ORIGINATION FORM

Proposed Revisions to a Standard Plans Index

Index Number: 654-001

Index Title: Rectangular Rapid Flashing Beacon Assembly

LAST REVISION 11/01/21 11/01/23	DESCRIPTION: 11/01/23		FY 2023-24 STANDARD PLANS	RECTANGULAR RAPID FLASHING BEACON ASSEMBLY	INDEX 654-001	SHEET 2 of 2
--	--------------------------	--	------------------------------	--	------------------	-----------------

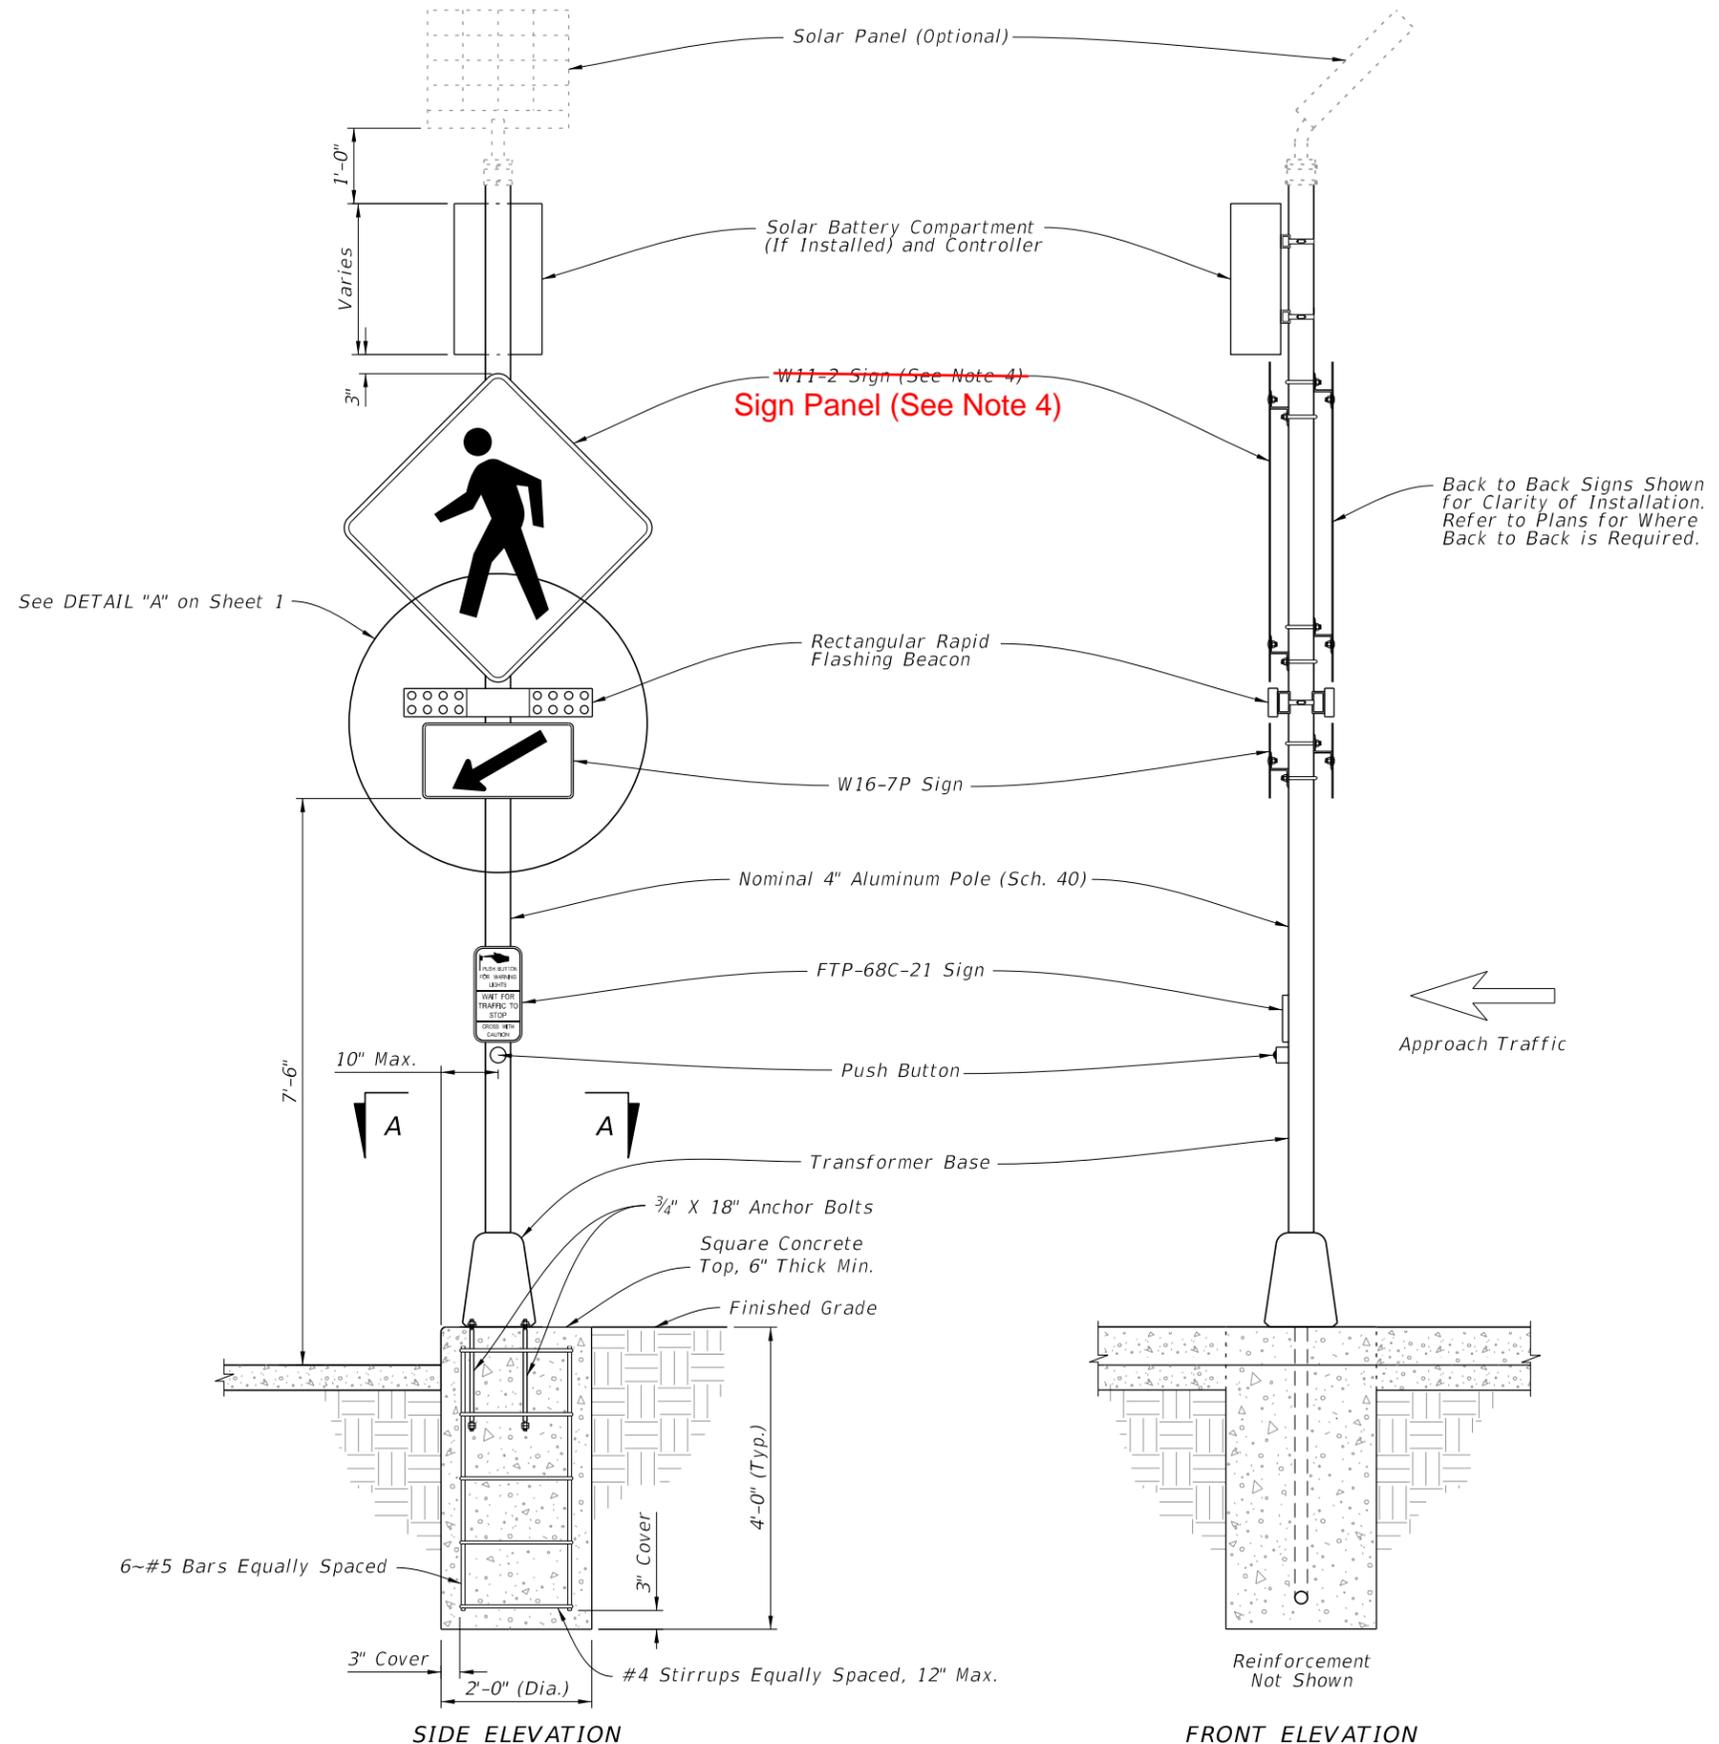
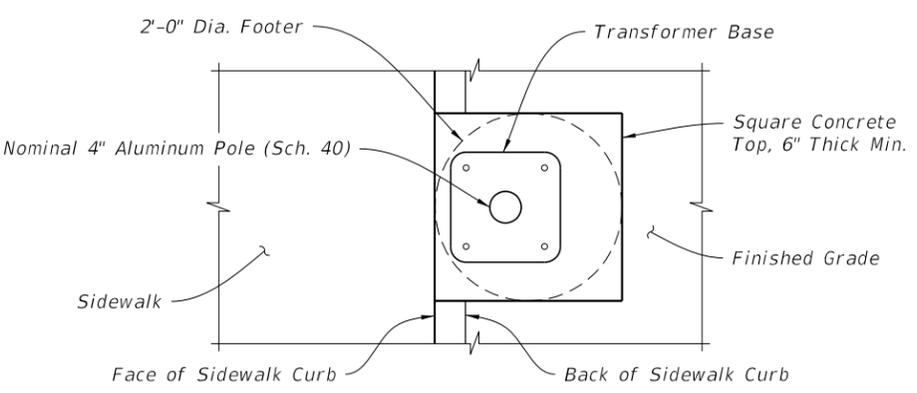
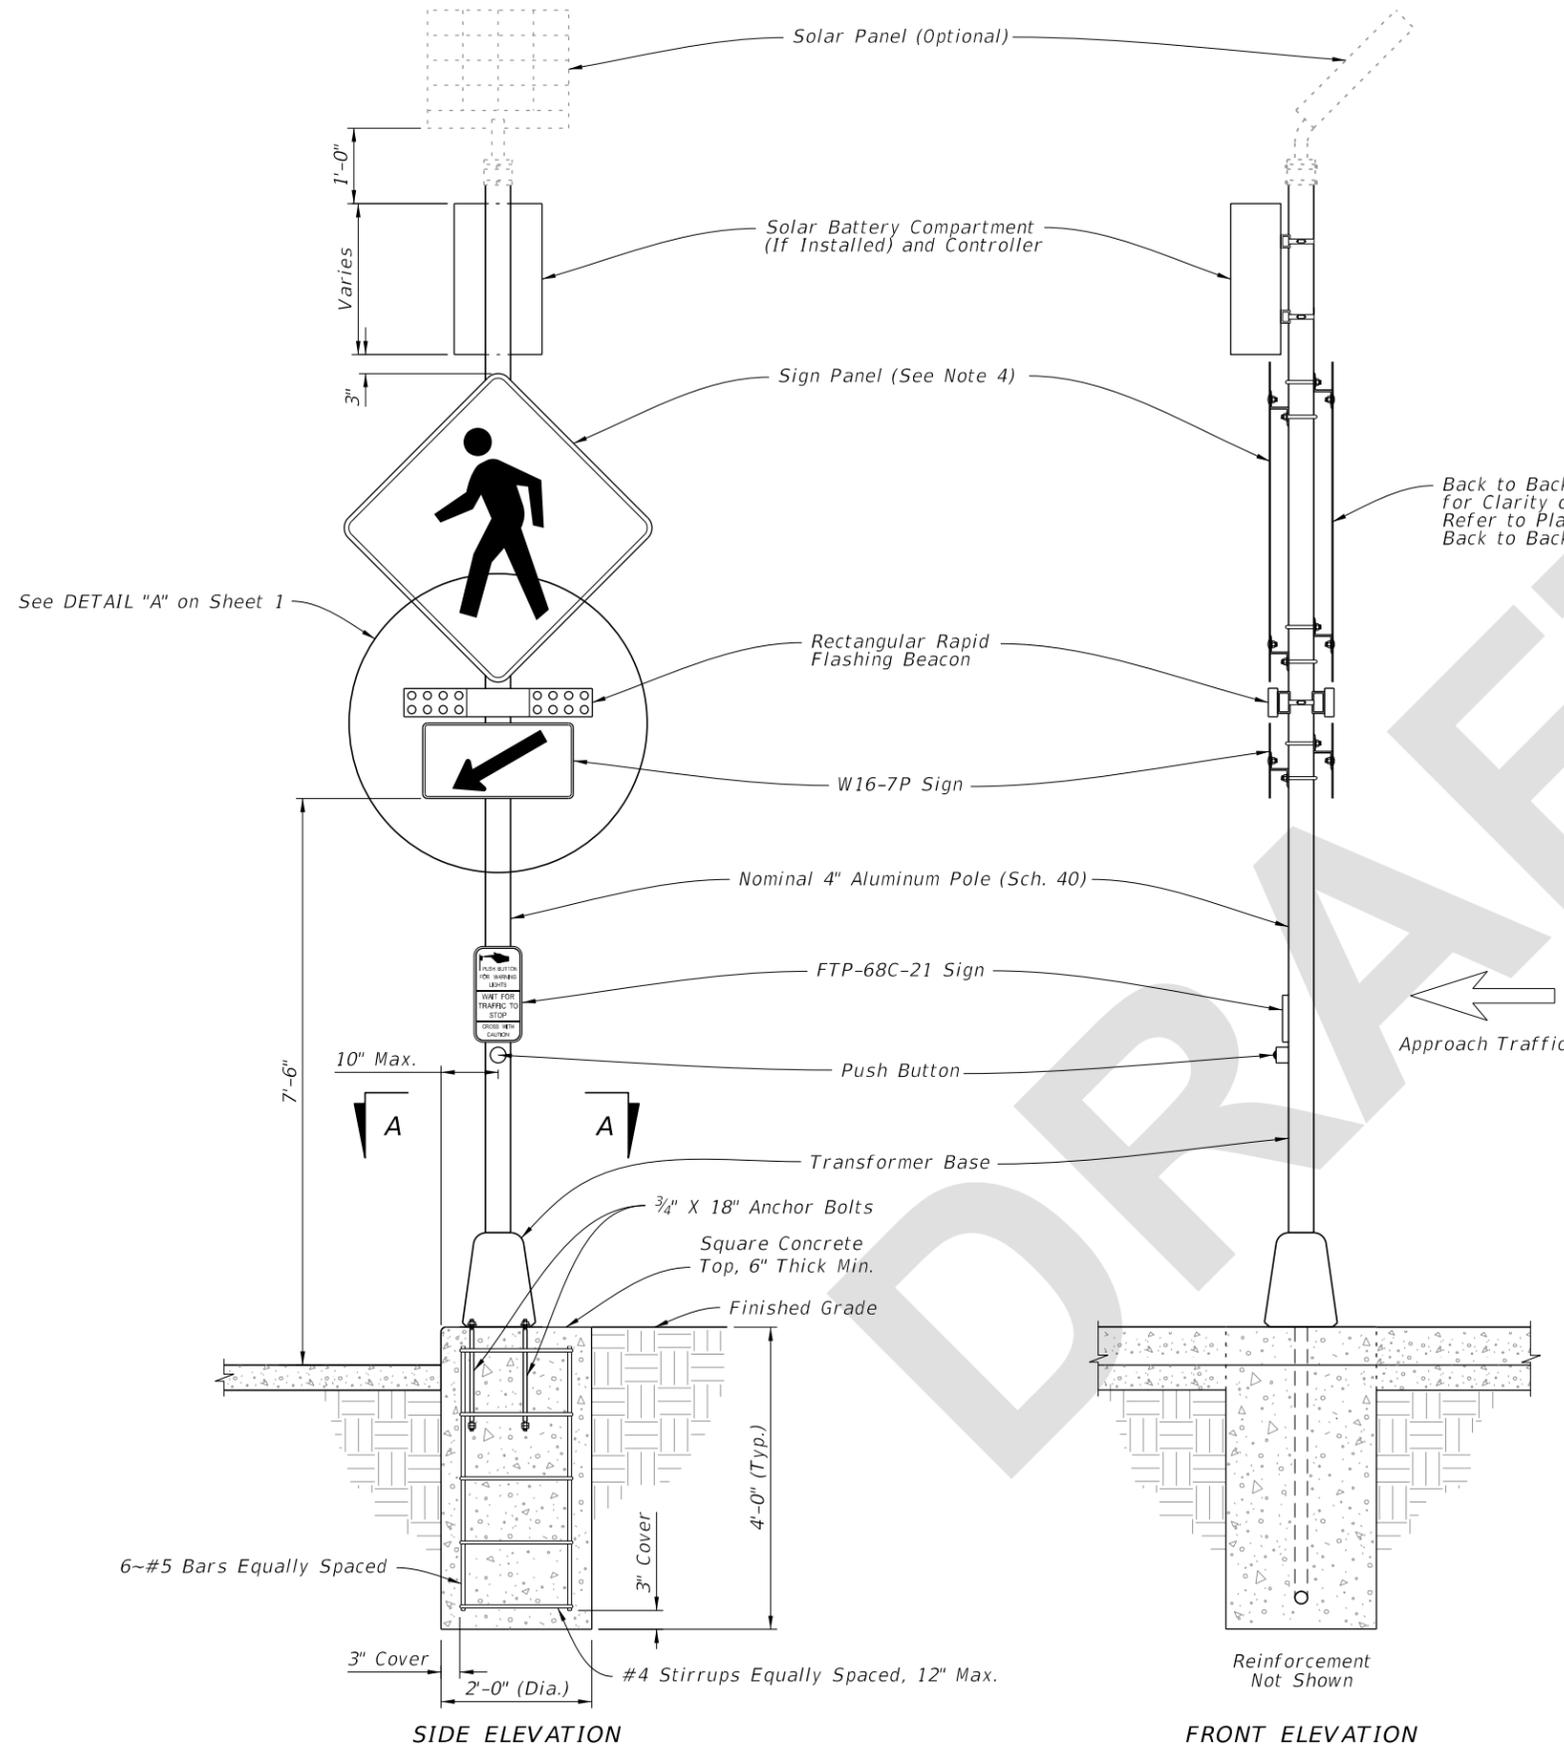
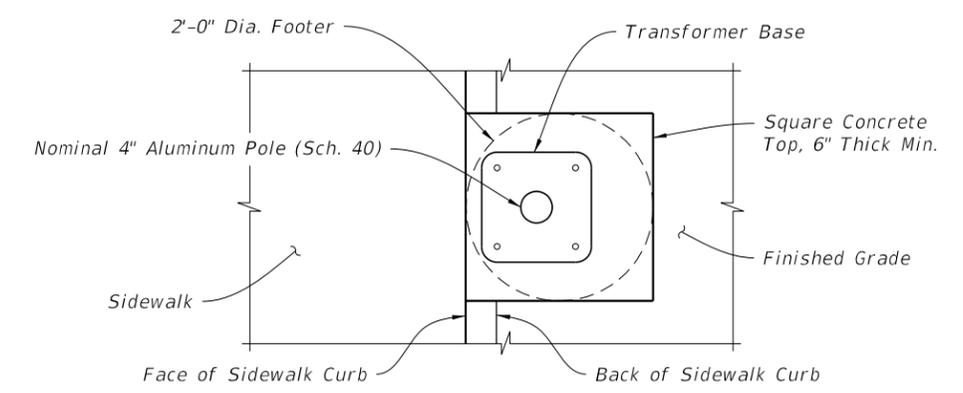
Sheet 2: Updated callout to "Sign Panel (See Note 4)".
